P86 Dispenser Shutter – Sensor Sensitivity

Below is a picture of the shield made for the shutter.

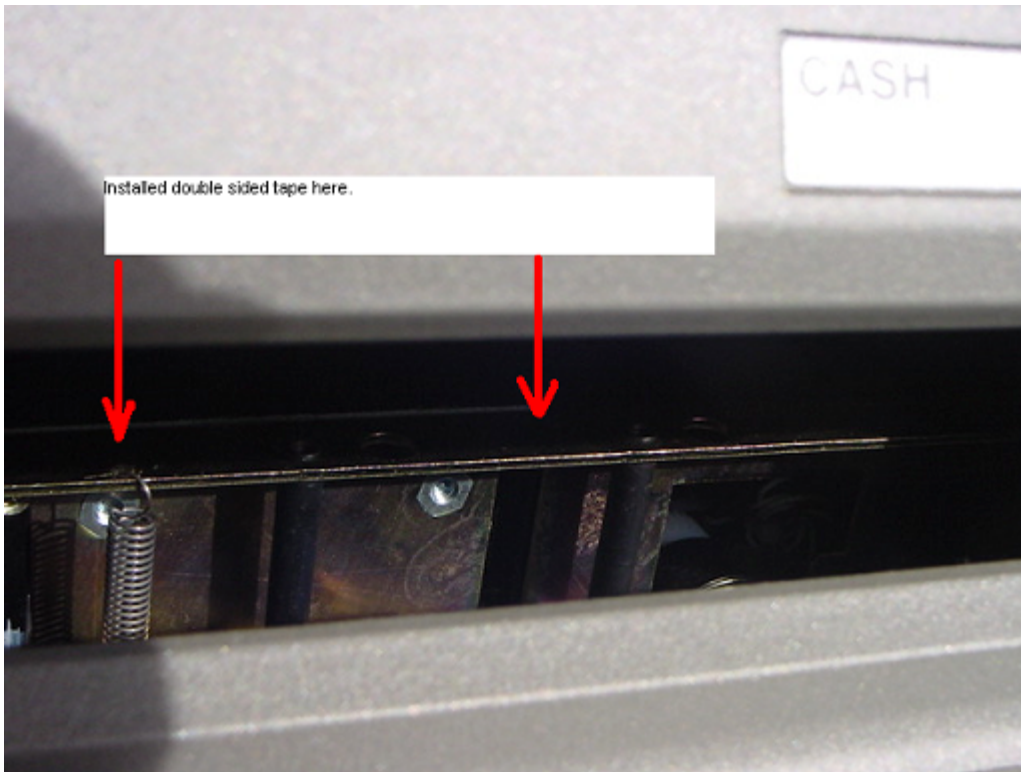
If this problem is being experienced and a solution is needed urgently it is possible to implement a temporary workaround. This workaround was developed by the Customer Engineers in the USA and has been proven to minimize this issue. The workaround is intended to prevent sunlight reaching the shutter sensor by fitting a shield on the shutter mechanism.

The shield should be made out of a very thin cardboard (1mm) and should be 192mm x 65mm in size.
